# City of San Antonio

Re: **Bulverde Market**

**MDP # 014-08**

The Development Review Committee has reviewed **Bulverde Market** Master Development Plan or **MDP 014-08**. Enclosed is an accepted and signed copy of the MDP for your files. However, please note the following conditions:

**BULVERDE MARKET MASTER DEVELOPMENT PLAN**

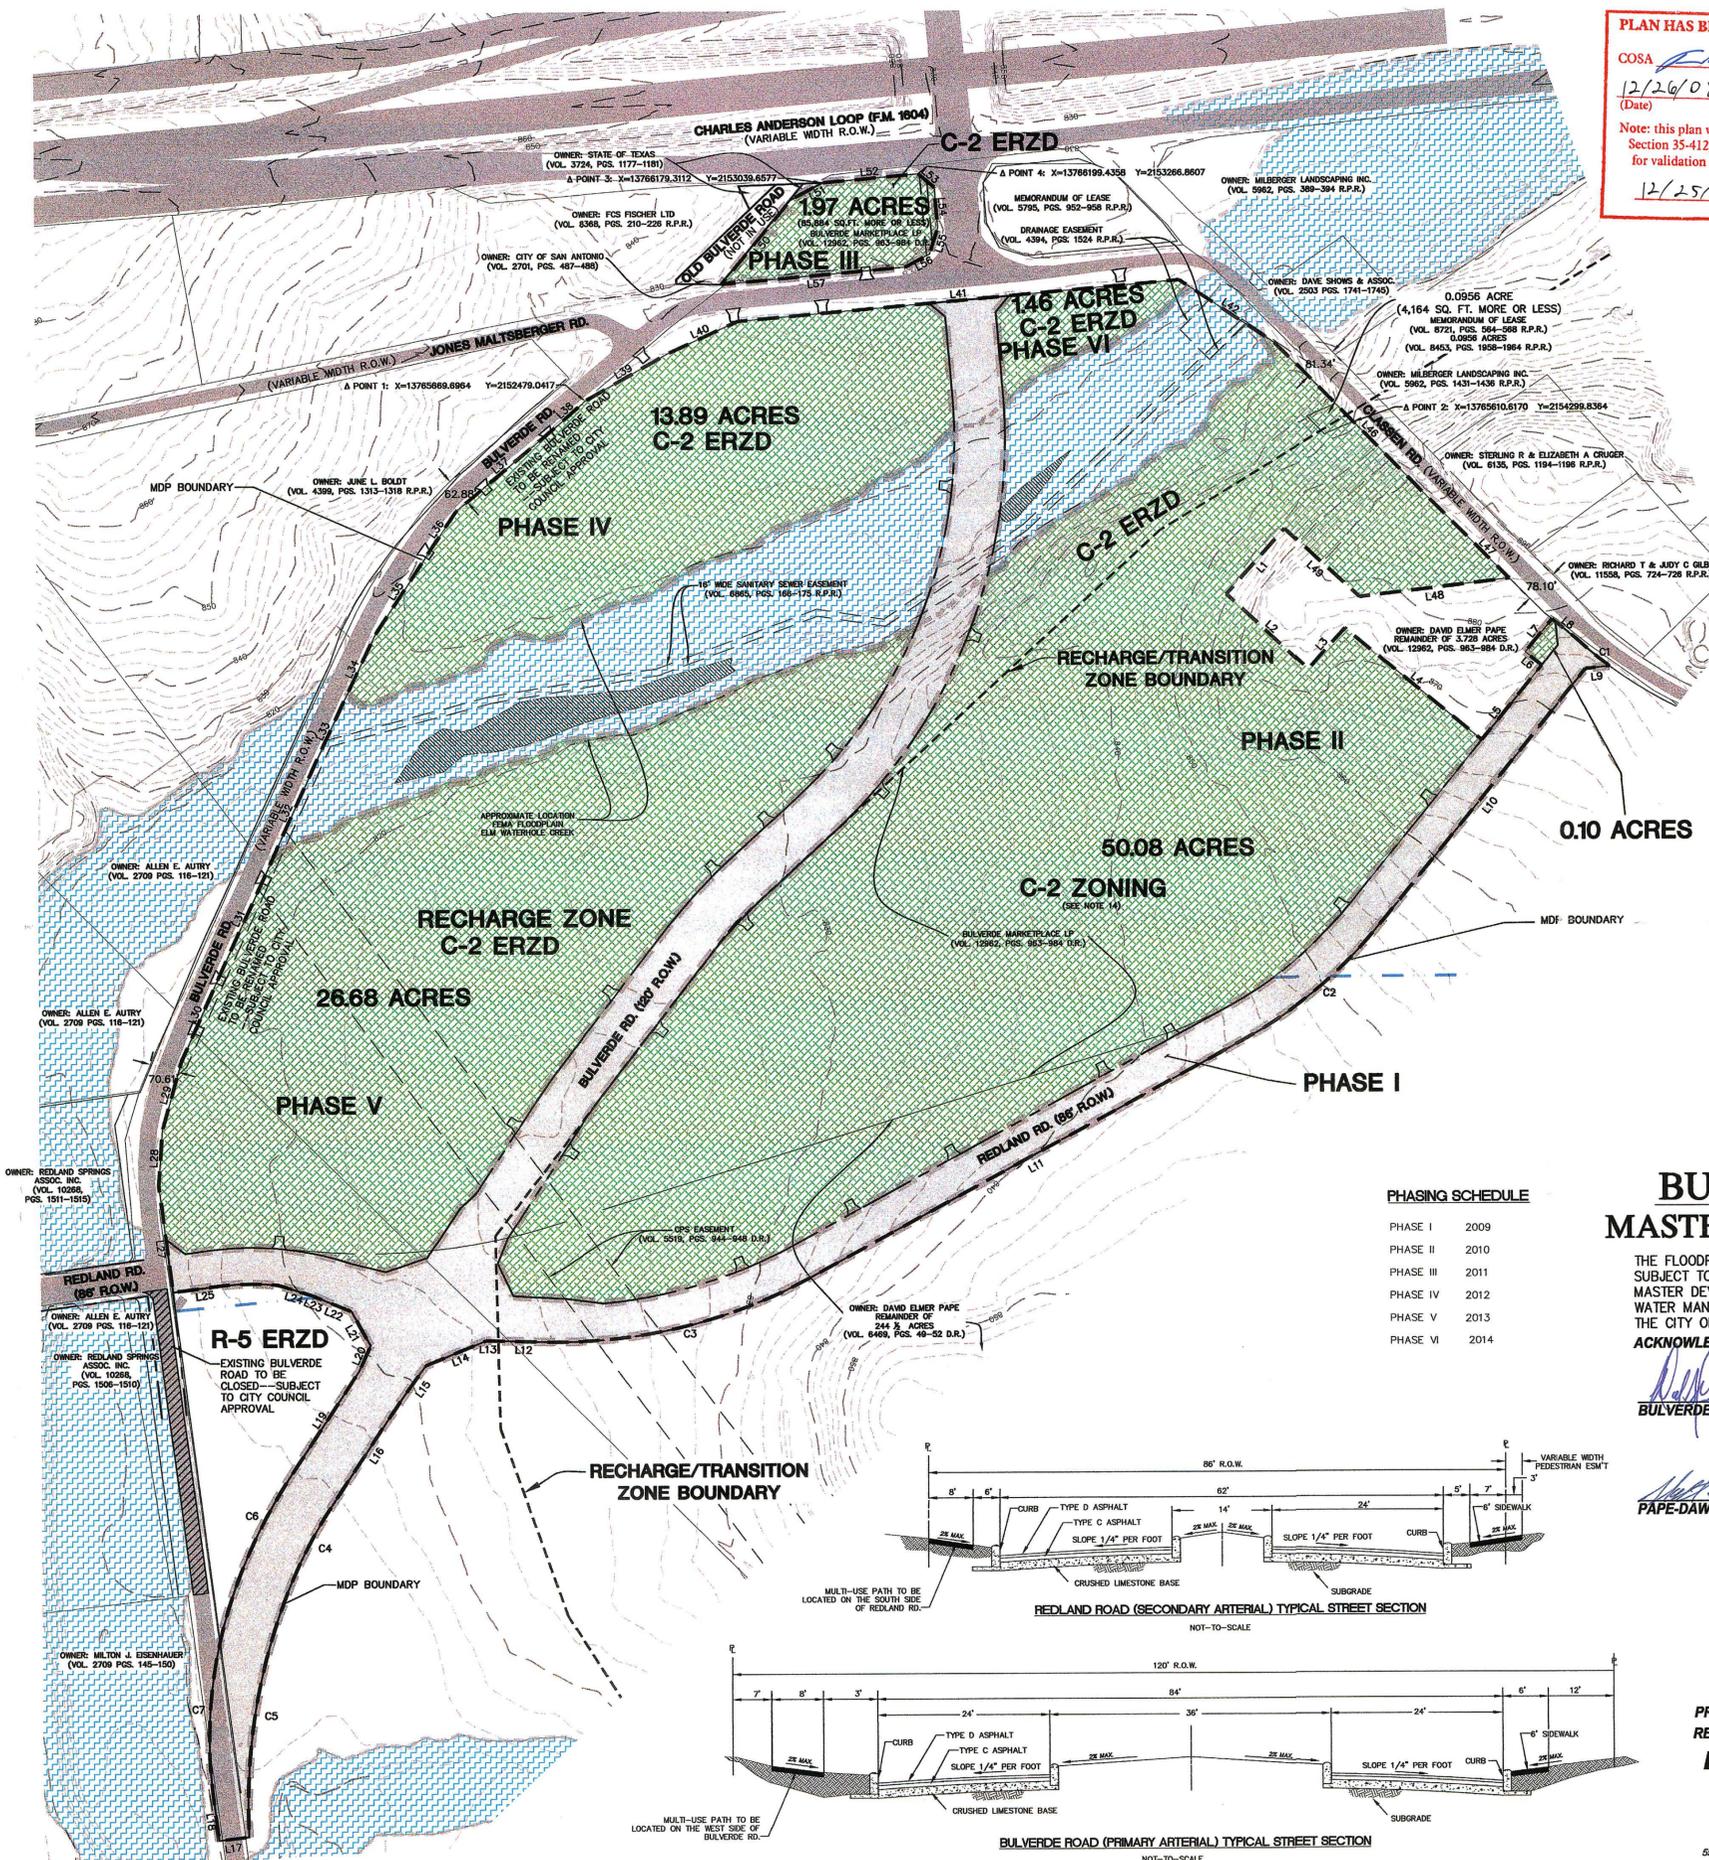
It will be expected that all of the property depicted in the Master Development Plan including but not limited to floodplains, drainage areas, and open space shall be platted. All platting shall comply with the Unified Development Code (UDC), the City's Master Plan, Major Thoroughfare Plan, and all applicable regulations for the City of San Antonio.

The Texas Sites Atlas indicates that no archaeological sites have been previously identified within the above referenced property. However, over 12 archaeological sites have been recorded in close proximity to the project area, in particular along Elm Waterhole Creek that runs through the development. Therefore, the property may contain sites, some of which may be significant. Thus, before any work that might affect any sites is begun we recommend that a qualified professional conduct an archaeological investigation of the property. The investigation should be performed according to Archeological Survey Standards for Texas, and any previously identified sites should be reexamined and reevaluated, if any. A list of qualified archaeological consulting firms is available on line at [www.c-tx-arch.org](http://www.c-tx-arch.org). The consultant may need to obtain an antiquities permit from the SHPO prior to starting the investigation. A report of findings should be prepared according to the Council of Texas Archeologists [CTA] Guidelines for Cultural Resource Management Reports and submitted to the HPO and SHPO for review. Copies of the survey standards and the CTA guidelines may be obtained by calling the SHPO at 512-463-6096 or writing

- 100 year Flood Plain Shown and Buffering (If applicable)
- Significant Recharge Features and Buffering (If applicable)
- Category Letter for All Site Specific Plats (If Category 2 or 3, an Aquifer Protection Plan is required)
- Approximately 81.25 acres, of the total 134.98 acres of the project are located within the Edwards Recharge Zone and are subject to the Aquifer Protection Ordinance No. 81491. According to the Aquifer Protection Ordinance No. 81491 Section 34-914 floodplain buffering may be required. Any wells found on the property shall be properly plugged for plugging procedures contact Monty Mc Guffin with the San Antonio Water System at (210) 233-3556.
- Additionally, a Water Pollution Abatement Plan or Contributing Zone Plan must be submitted to and approved by the Texas Commission on Environmental Quality (TCEQ) prior to construction.
